Executive Order G-70-7-D

Relating to the Modification of the Certification of the Gulf/Hasselmann VCP-2 and VCP-2A Service Station Phase II Vapor Recovery Systems

EXECUTIVE ORDER G-70-7-*D*

Nozzle Configuration

EXHIBIT 1

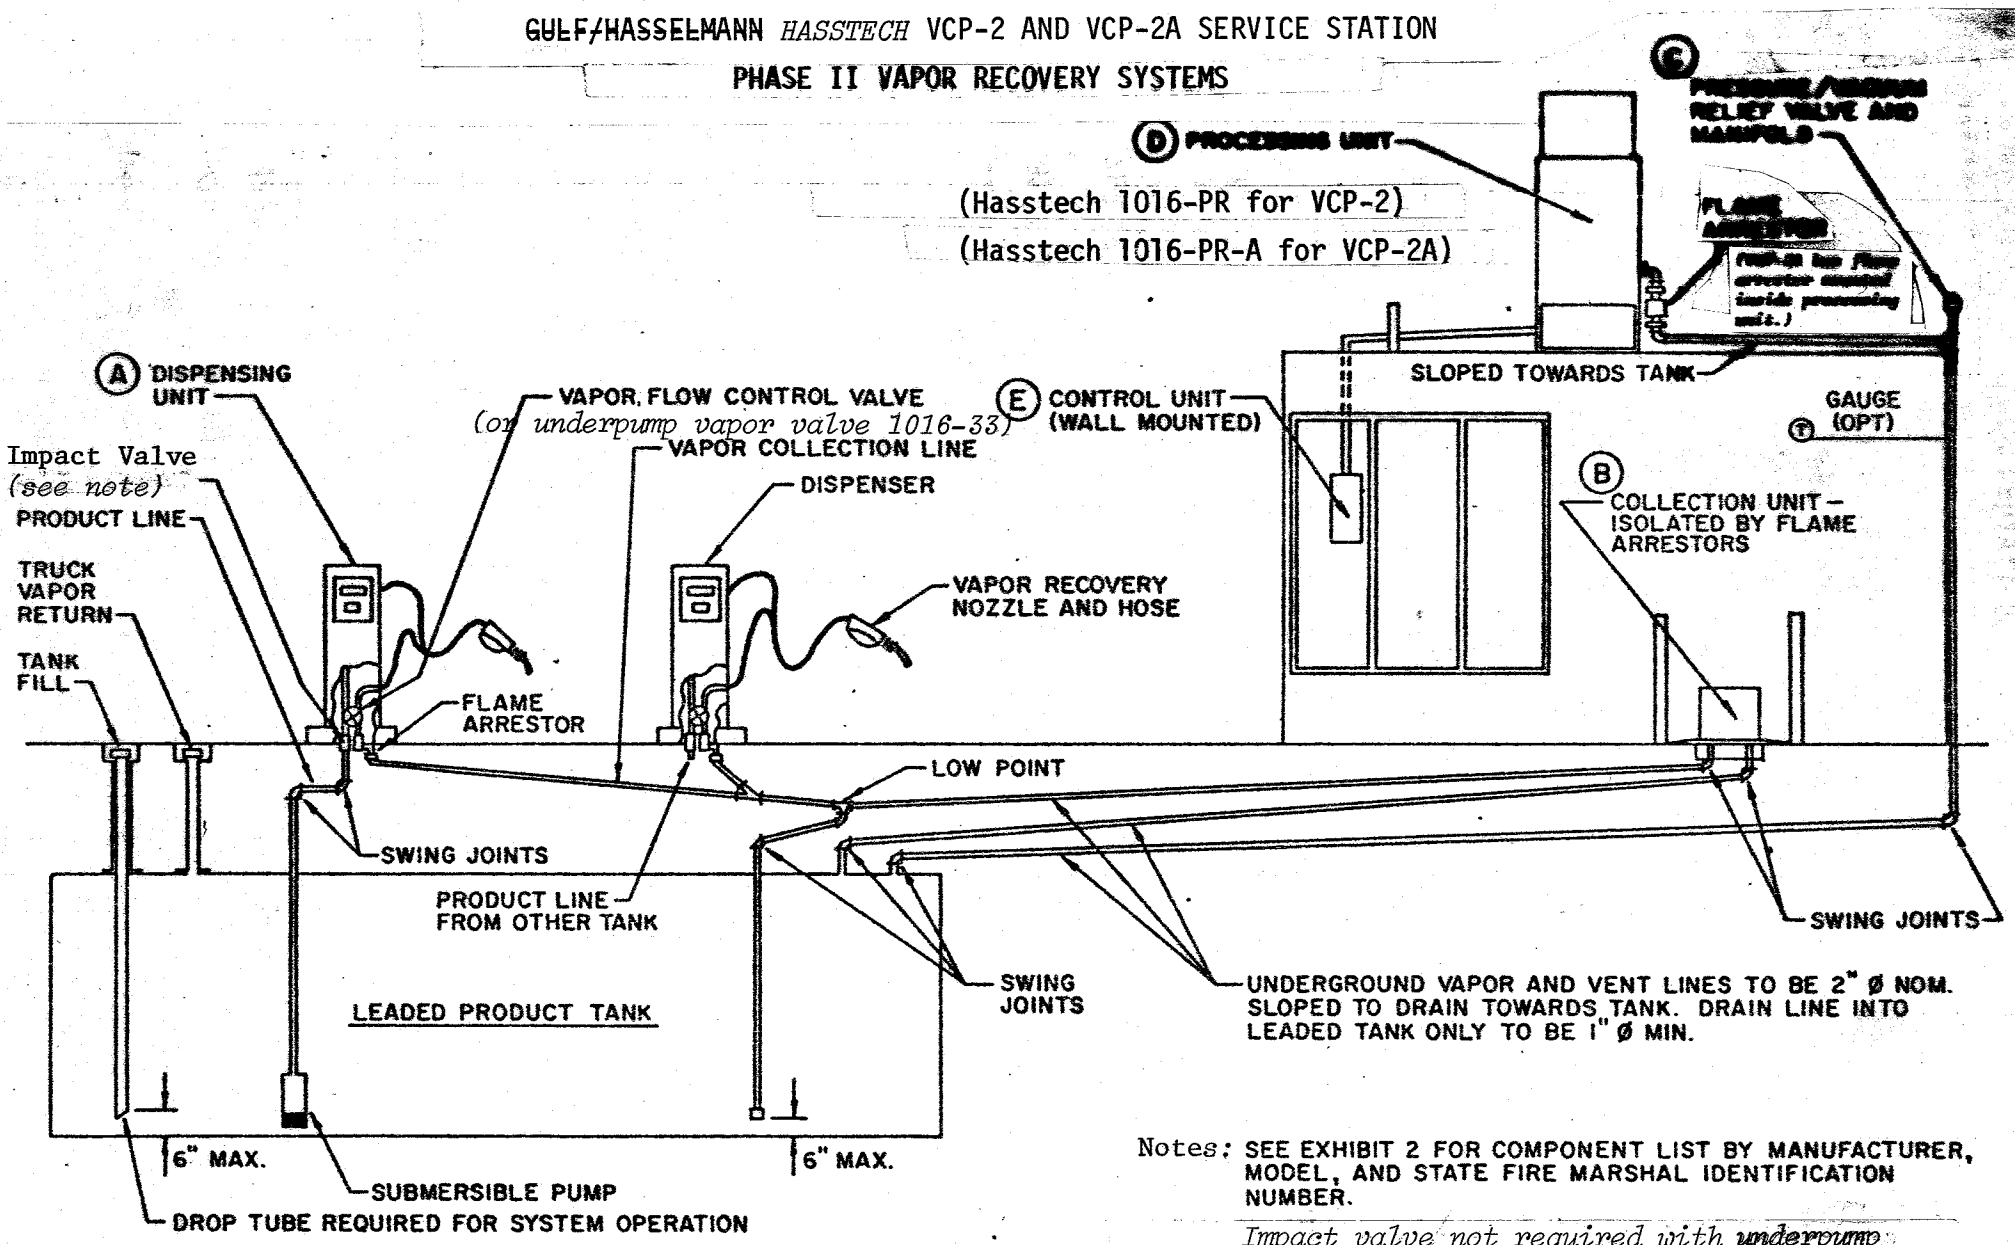
Impact valve not required with underpump vapor valve, Hasstech component 1016-33.

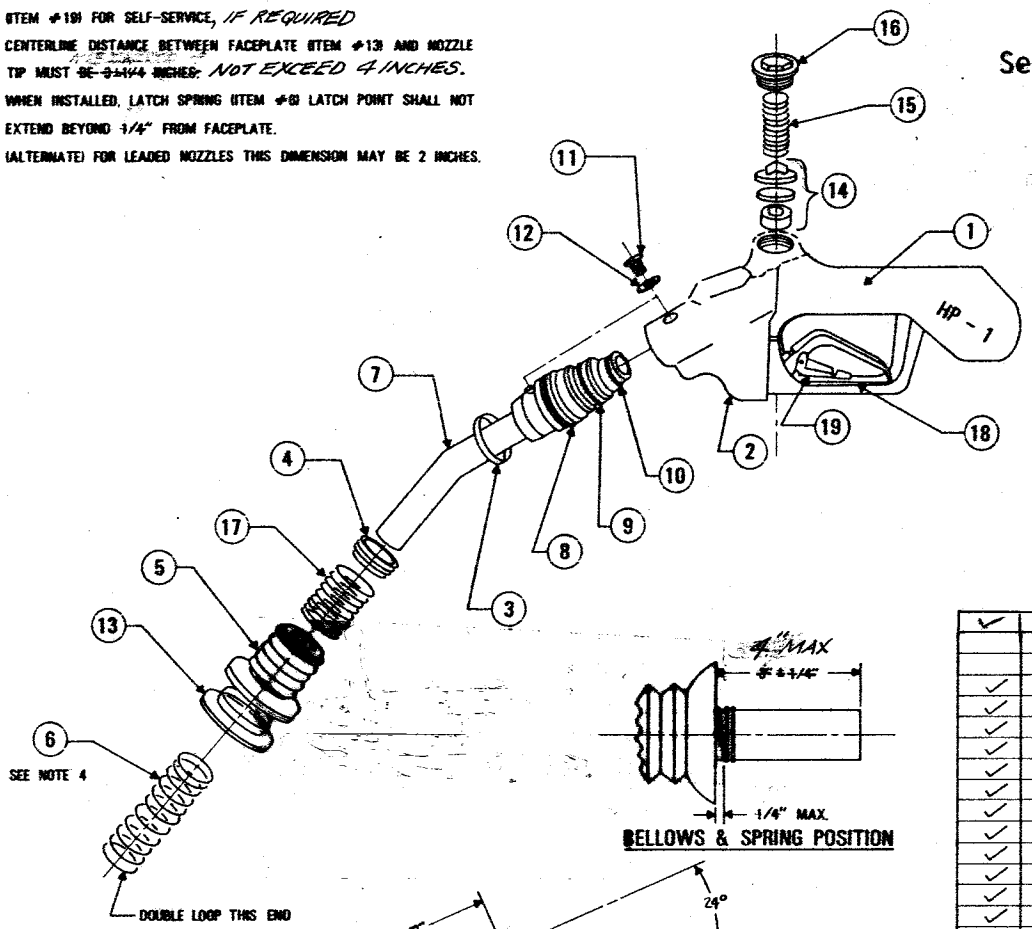
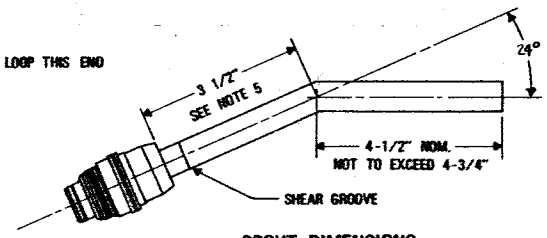
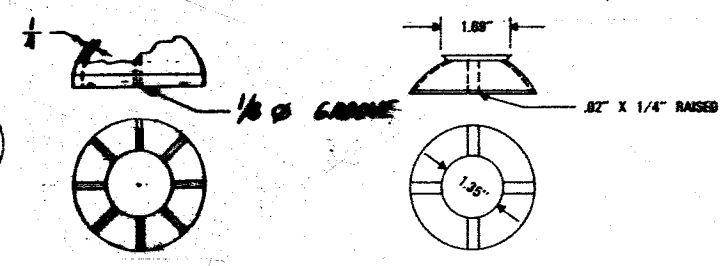
1. An alternative spout extension (4 in.) for the nozzle;

2. An alternative bellows/faceplate unit made of polymer compound for the nozzle;

1. NOZZLE TO MEET REQUIREMENTS OF UNDERWRITERS LABORATORY, INC. STANDARD 842 (1974).
2. REMOVE HOLD OPEN LATCH TRIGGER (ITEM #18) & TRIGGER SPRING (ITEM #19) FOR SELF-SERVICE, *IF REQUIRED*
3. CENTERLINE DISTANCE BETWEEN FACEPLATE (ITEM #13) AND NOZZLE TIP MUST ~~BE 3-1/4 INCHES.~~ *NOT EXCEED 4 INCHES.*
4. WHEN INSTALLED, LATCH SPRING (ITEM #8) LATCH POINT SHALL NOT EXTEND BEYOND 1/4" FROM FACEPLATE.
5. (ALTERNATE) FOR LEADED NOZZLES THIS DIMENSION MAY BE 2 INCHES.

~~FACEPLATE~~
~~ITEM: 13 - 1~~
~~ALTERNATE~~
BELLOWS
ITEM 5C

FACEPLATE
ITEM: 13 - 3
~~MAT'L: AL-ALLOY~~
(ALTERNATE)

Note: Revisions to Executive Order G-70-7-C noted in italics
